Reply

# Orientation Control System: Enhancing Aerial Maneuvers for Quadruped Robots

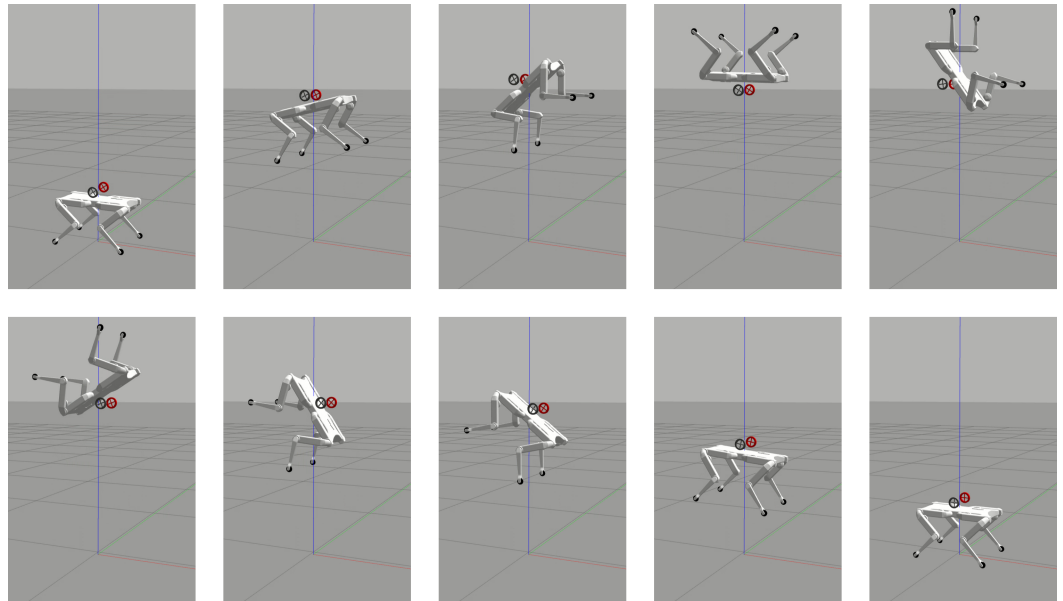
- **Comment 1:** *'All the simulations are performed in Gazebo'. The paper must have more details related with the simulation, including a snapshot of the simulated robot in its environment.*

**Response:** Thank you for the insightful comment. We summarized the details of the simulation in Table 1, which is incorporated to the manuscript too. Moreover, inspired by your suggestion, we attached a sequence of snapshots for the third simulation (back-flip), showing the robot in the Gazebo environment (Fig. 1).
